| Office Action Summary | Application No. 10/674,704 | Applicant(s) OPHEIM, TONY A. | |

- 1) ☒ Responsive to communication(s) filed on 11 July 2005.
- 2a) ☒ This action is **FINAL**. 2b) ☐ This action is non-final.
- 3) ☐ Since this application is in condition for allowance except for formal matters, prosecution as to the merits is closed in accordance with the practice under *Ex parte Quayle*, 1935 C.D. 11, 453 O.G. 213.

DETAILED ACTION

Fig. 6

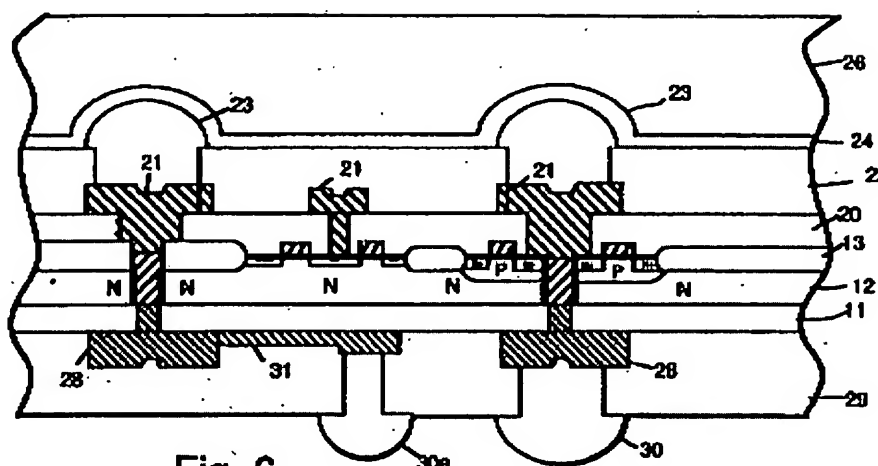
6. Regarding claim 1, Finnila (e.g. figs. 6) shows a die comprising: a dielectric layer 20/13 positioned on top of a semiconductor support layer 11/12; a via passing through the dielectric layer and the semiconductor support layer, wherein a first end of the via is positioned in the dielectric layer and a second end of the via is positioned in the semiconductor support layer, wherein a first diameter of the first end is greater than a second diameter of the second end; and a contact 21 positioned on top of the dielectric layer, the contact coupled to the first end of the via, wherein the contact to be coupled to a device of the die (e.g. transistor).

7. Regarding claim 7, Finnila shows that the via includes a metal filled via (col. 4/II.

Fig. 2D

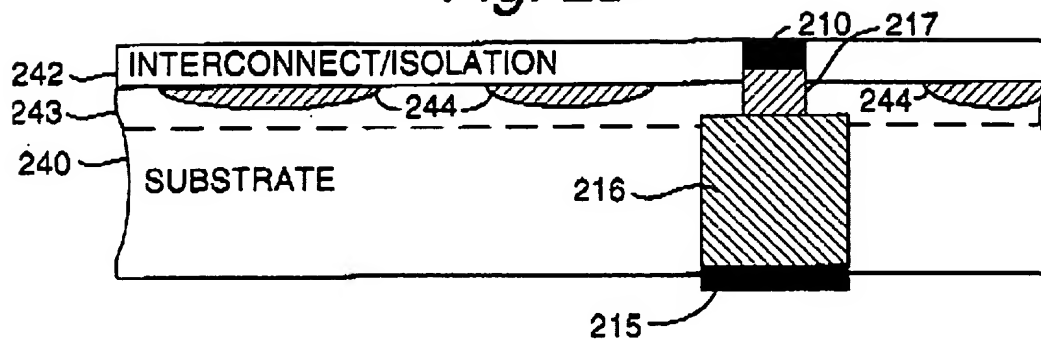
9. Claims 2 is rejected under 35 U.S.C. 103(a) as being unpatentable over Finnila (US 5,426,072) in view of Hsuan (US 6,429,509).
10. Regarding claim 2, Finnila shows most aspects of the instant invention except for a shaft between the first end and the second end wherein the shaft has a diameter similar to the second diameter. Nevertheless, Hsuan (e.g. fig. 2D) a via including a shaft between a first end 216 and the second end 217 wherein the shaft has a diameter similar to the second diameter.

According to Hsuan, this type of interconnection minimizes the I/O signal attenuation, inductance and capacitance of integrated circuit (col. 3/lls. 42-45). It would have been obvious to one of ordinary skill in the art at the time the invention was made to make the vias disclosed by Finnila having a shaft between the first end and the second end wherein the shaft has a diameter similar to the second diameter in accordant to Hsuan's invention to minimize the I/O signal attenuation, inductance and capacitance of integrated circuit.

15. Regarding claim 25, Finnila in view of Gnadinger shows most aspects of the instant invention except for a shaft between the first end and the second end wherein the shaft has a diameter similar to the second diameter. Nevertheless, Hsuan (e.g. fig. 2D) shows a via including a shaft between a first end 216 and the second end 217 wherein the shaft has a diameter similar to the second diameter. According to Hsuan, this type of interconnection minimizes the I/O signal attenuation, inductance and capacitance of integrated circuit (col. 3/lls. 42-45). It would have been obvious to one of ordinary skill in the art at the time the invention was made to make the vias disclosed by Finnila having a shaft between the first end and the second end wherein the shaft has a diameter similar to the second diameter in accordant to Hsuan's invention to minimize the I/O signal attenuation, inductance and capacitance of integrated circuit
